Burlington Development Review Board

Development Review Board

Tuesday, September 16, 2025, 5:00 PM

To: Development Review Board
From: Mary O'Neil, AICP, Principal Planner
Date: September 16, 2025
RE: ZP-25-370; 23 Isham Street

1 SECONDARY - EAST ELEVATION
A21 SCALE: 1/4" = 1'-0"

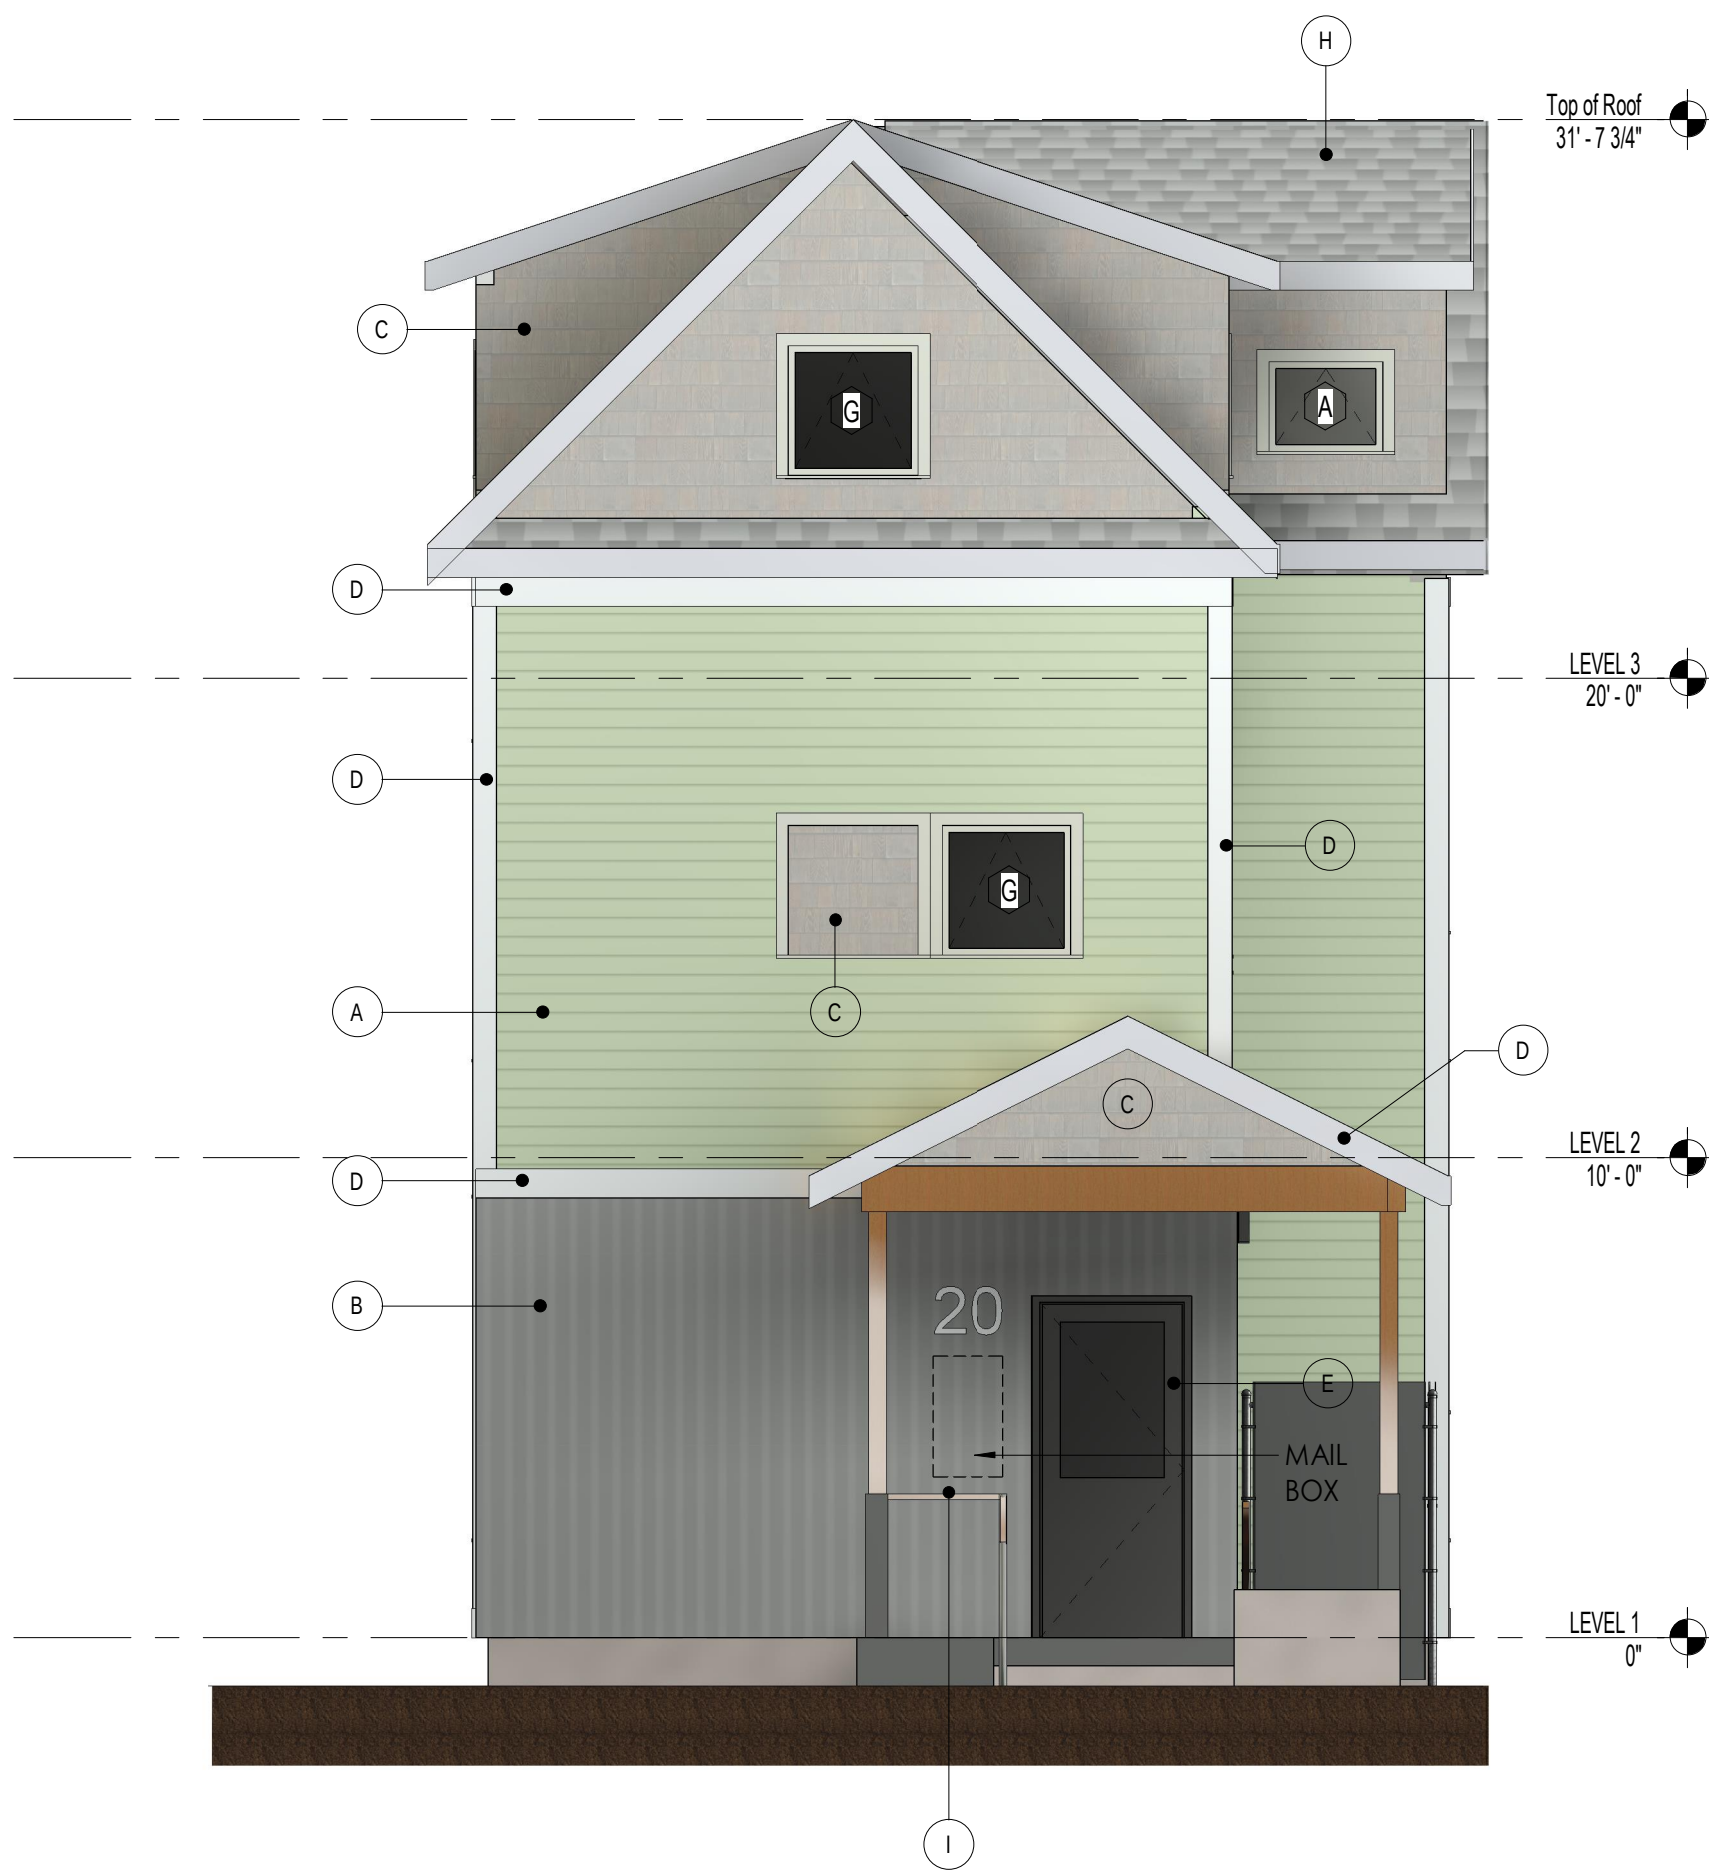
Window openings on the south and west are placed in some predictable pattern. Smaller openings flag kitchens and bathrooms; sliders are placed above living room couches. The “blind” window opening on the primary (east) façade is awkward and begs a different solution (Plan A.21), but moreso suggests that a revised floor plan placing the internal staircase at the rear of the structure would allow greater glazing opportunities for key rooms (kitchen, living room) while moving secondary functions like trash, recycling, and parking access to the rear.

Mailbox location is now identified on the east elevation (Plan A2.1). Condensing units have been relocated to the rear (west) of the Secondary building. Trash and recycling are shown within an enclosure on the north elevation. A landscaping plan is required.
